ACP ORAL HEARING (ONLINE)  
CPO UE ADARE RATIONALISATION SCHEME

EVIDENCE PRESENTED BY JOHN DORE  
FBA CONSULTANTS

MR. NED HOULIHAN (OBJECTOR)

18<sup>TH</sup> FEBRUARY 2026

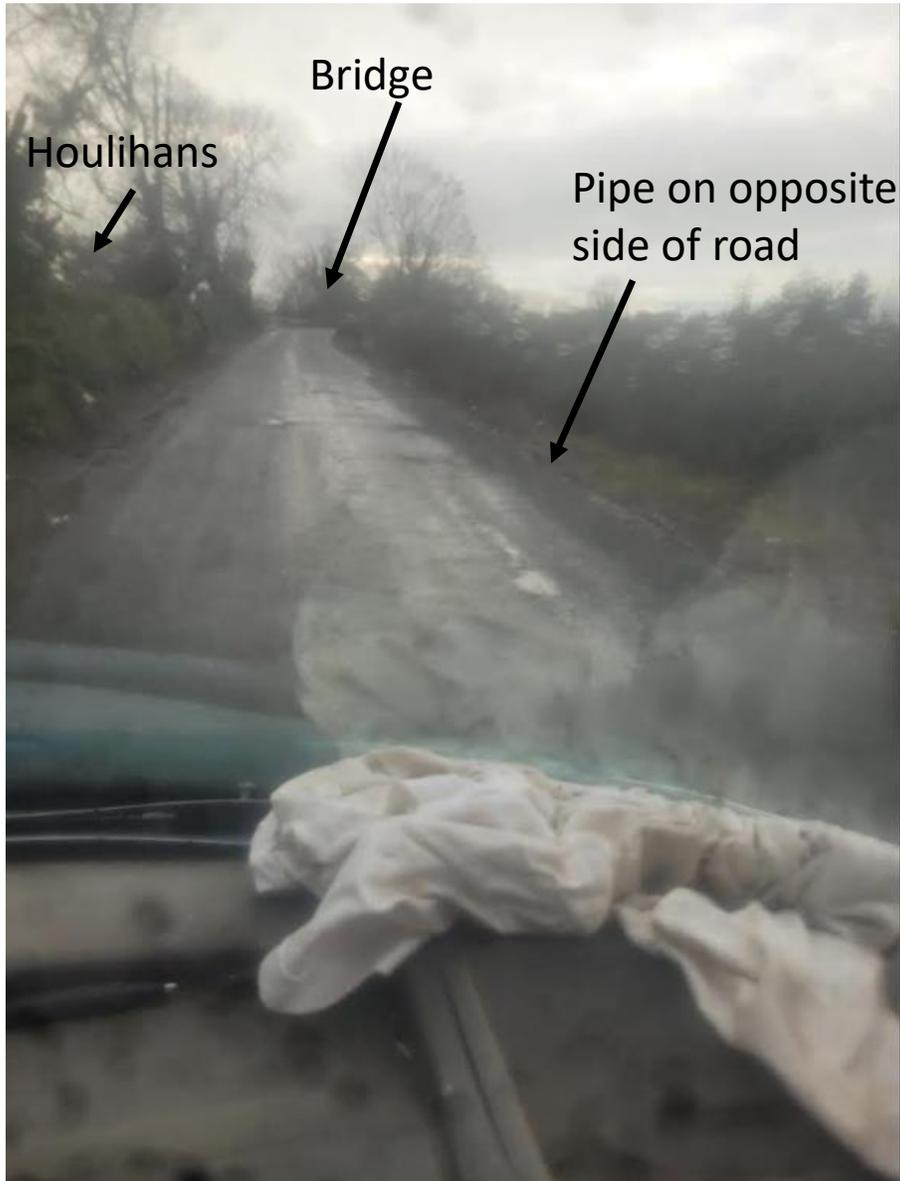
A. The ‘proposed route’ as provided for in Fig 1 of the Letter of Objection does not reflect the proposed route of Uisce Éireann. The objector shows the route located in the land across the road from his land before crossing the road and entering his land. This is inaccurate. The designed route is within the public road and enters private land either side of the river crossing.

B. The length of the proposed route shown in Fig 1 of the Letter of Objection does not accurately reflect the temporary working area to accommodate the pipe string. The CPO drawing UE/10051295/CWL/0002 shows the extents of the route in question.

We did not have any documentation or drawings to work on at the time the CPO was issued save for the CPO map issued. The objector requested such information but we did not receive any until 9/2/26

The drawing on the CPO planning report received does not match the works that have already been conducted

Pipe is on objectors side of the road in drawing – there are no road crossings visible?

## Route selection report

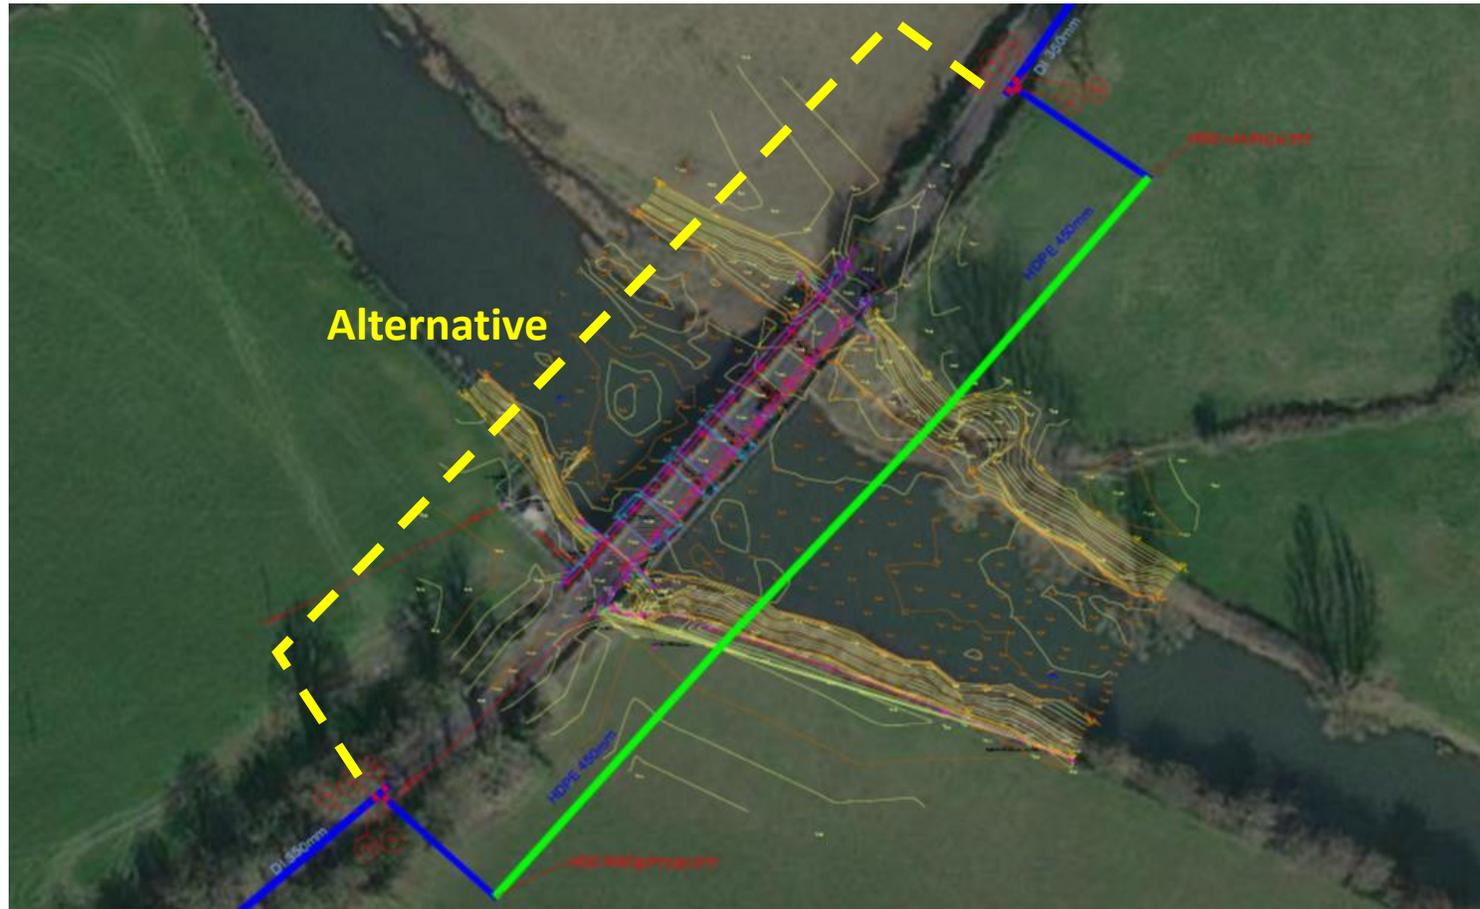
It is not clear as to when, why and how the route of the river crossing was selected. Now that we have drawings here is a suggested alternative crossing for the opposite side of the road

Figure 5. Details of Otter Activity in the vicinity of the works site.

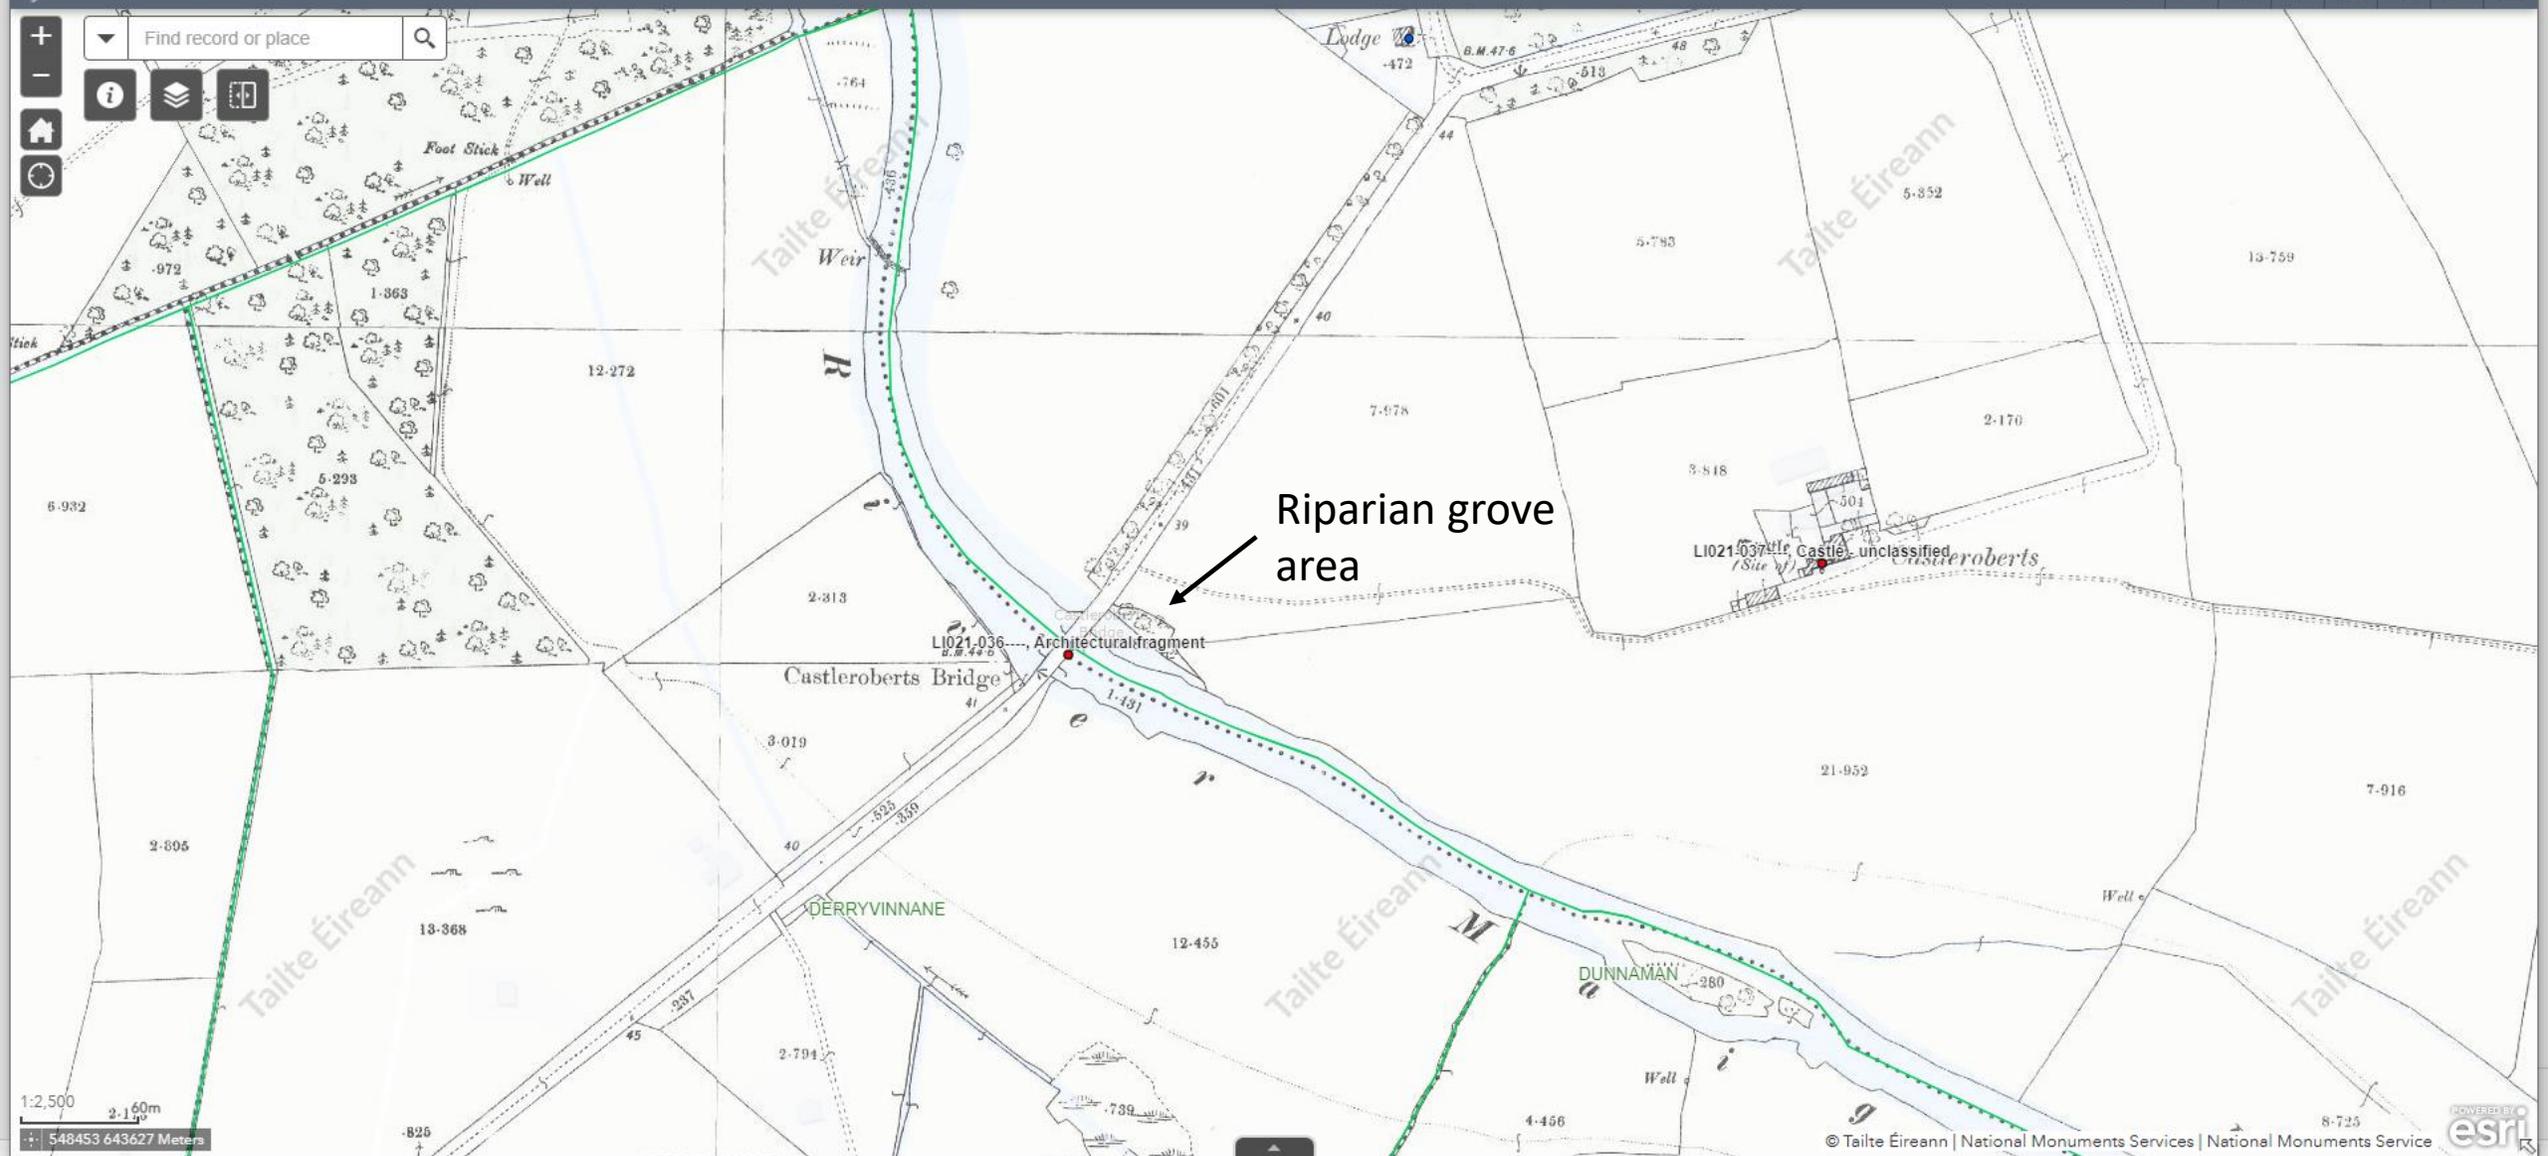
D. Regarding the concern to the objector’s side of the bank being more ecologically Sensitive the Appropriate Assessment Screening report addresses this. “No direct impacts QI (Qualifying Interests) species are predicted as works areas contain no suitable habitat, with exception of Otter. However, while Otter habitat is present, no direct impact that might affect this species are predicted due to the nature of the works and absence of holts/couches within close proximity of the works area. No in-stream works are planned as pipelines will be installed via HDD (Horizontal Directional Drilling), nor will work interfere with riparian otter habitat present as pits will be located 50m back from the riverbank. Otter couches present in the surrounding area are located within the distance allowed by NPWS

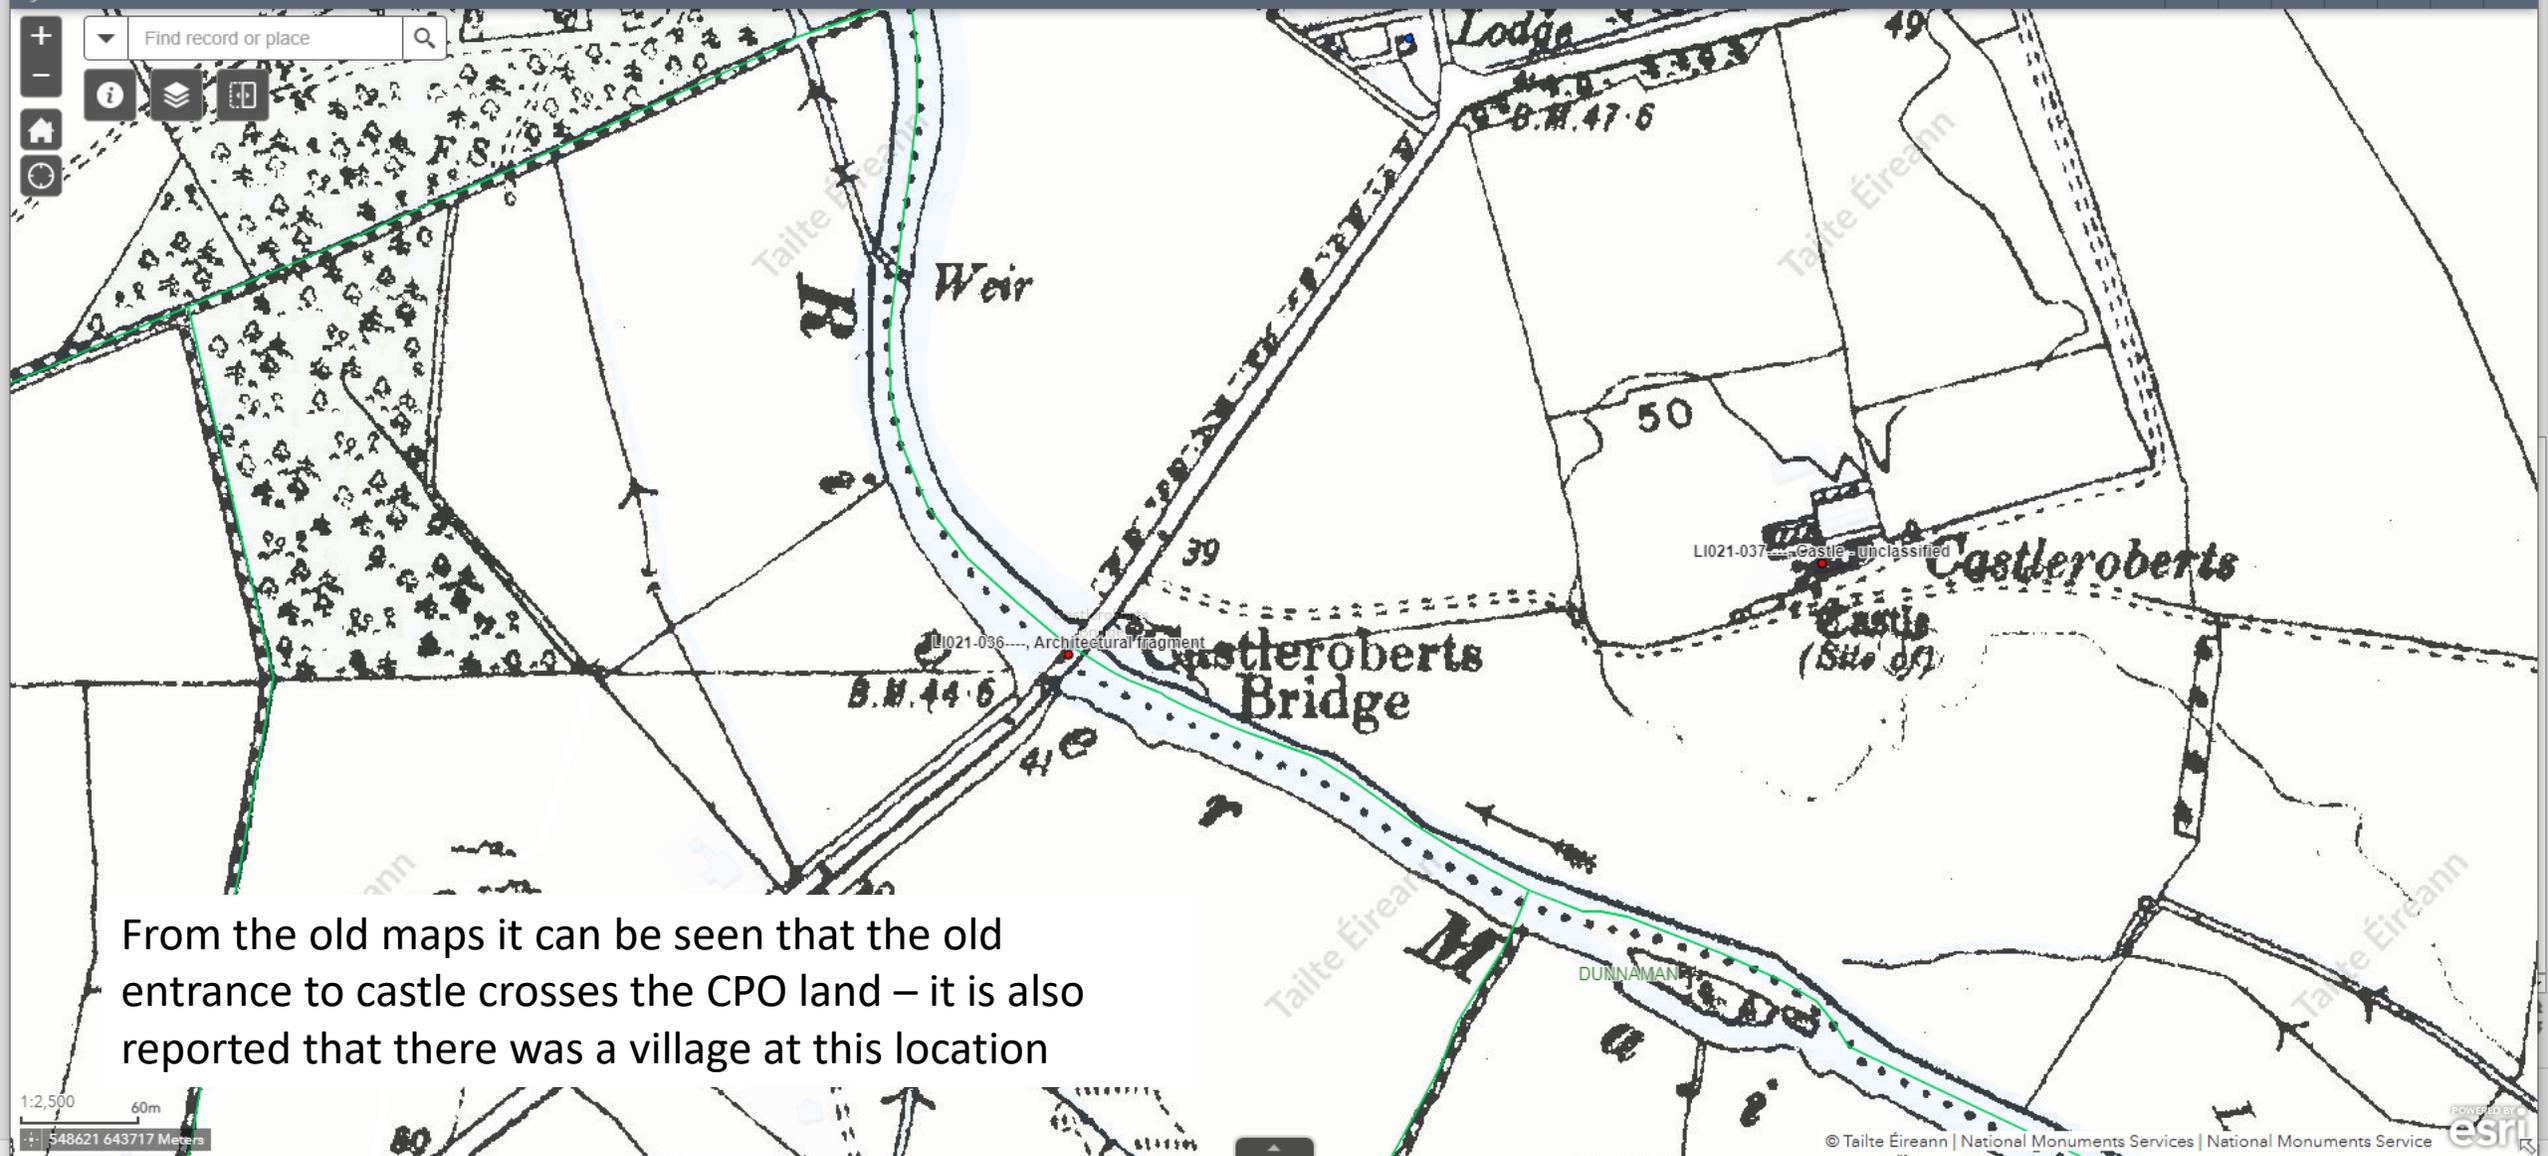
We contend that Mr Houlihan’s side of the road is far more archaeologically sensitive than the opposite side. The proposed location for the crossing is between two listed structures – Castleroberts Bridge and the castle at the centre of his holding. The bridge was built from the stone of the ruined castleroberts church which has a listed number but its location is unidentified but is understood to be also in close proximity

From the old maps it can be seen that the old entrance to castle crosses the CPO land – it is also reported that there was a village at this location
